The Heath & Hampstead Society

To London Borough of Camden, Tree Preservation Team

Planning Ref: 2022/0247/T
Address: 44 Denning Road London NW3 1SU
Case Officer: Tree Allocation
Date: 5th February 2022

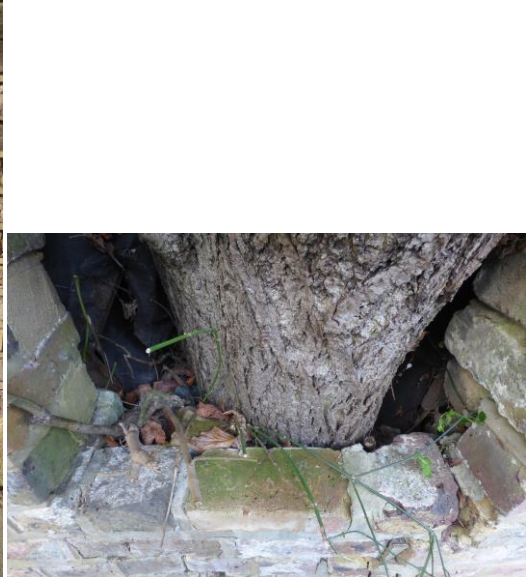
We agree with the arboriculturalist that a structural engineer is required to determine the fate of the wall. The wall by T1 & T2 is in a pretty damp state, by T1 it is in a parlous state, partly due to inappropriate cementitious pointing that has allowed frost damage of the bricks. It requires a significant degree of re-building, though Street View indicates this has been present and little different since 2017 at least.

The wall has been pushed on for many years by both T1 & T2's expanding trunks. The wall in front of T1's lower trunk has been cut out and replaced with a one-brick width thick wall, while the wall was extended out in the past to go in front of (but too close to) T2, with a minimal lean outwards, considerably inside a lean-angle of concern. Photo 4 seems to indicate this length of angled wall that is one-brick *length* thick and built to 'contain' T2 has not moved since, but T2 is up against it. Since risk is not an immediate issue, we suggest there be no rush to fell the trees, but advice sought from a structural engineer (as suggested but which has apparently not yet occurred) regarding how the wall in front of T1 and T2 can be safely re-built and supported *with the trees retained*. This could be done with complete gaps where both T1 and T2 are to allow for the trees' future growth long term, and for a slight degree of trunk movement during strong winds. Low weep holes may be recommended to drain the damp soil behind. Retention of the Conservation Area character by re-using these bricks with appropriate mortar/pointing will also be essential.

I suggest all the factors operating here require consideration by a structural engineer when planning to rebuild the walls, but that these three trees with high public amenity – as well as the lime tree on the neighbouring property with a low, now cracking, wall built very close around it – should all be retained for the future.
